1
ILLINOIS POWER COMPANY

Clinton Power Station Unit 1
Docket No. 50-461

In response to Mr. B. Jagannath's, HGEB reviewer, questions on settlement of Unit 1 due to Unit 2 construction, we are submitting the enclosed material.

CLARIFICATION ON PLANT SETTLEMENT

Figure 1 Time vs. Settlement for Till Layer under Radwaste Building
(at a Location Close to Unit 2) due to Construction of
Unit 2 at a Later Date

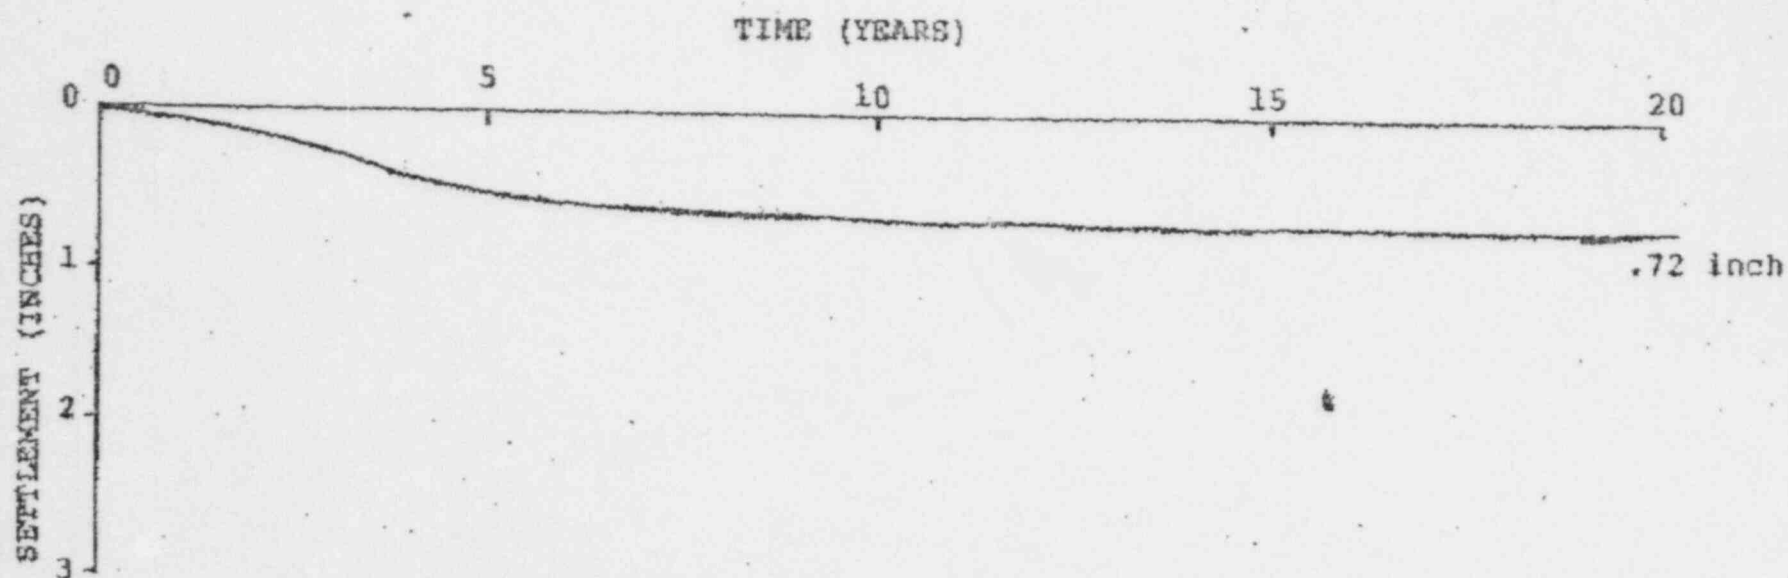
2. Provide a time-dependent settlement plot of the till layer under Unit 1 due to loads from Unit 2 when constructed at a later date.

The attached Figure 1 shows the settlement vs. time plot for the till layer under the radwaste building, which will be most affected by the loads from Unit 2. The final settlement is estimated to be 0.72 inches.
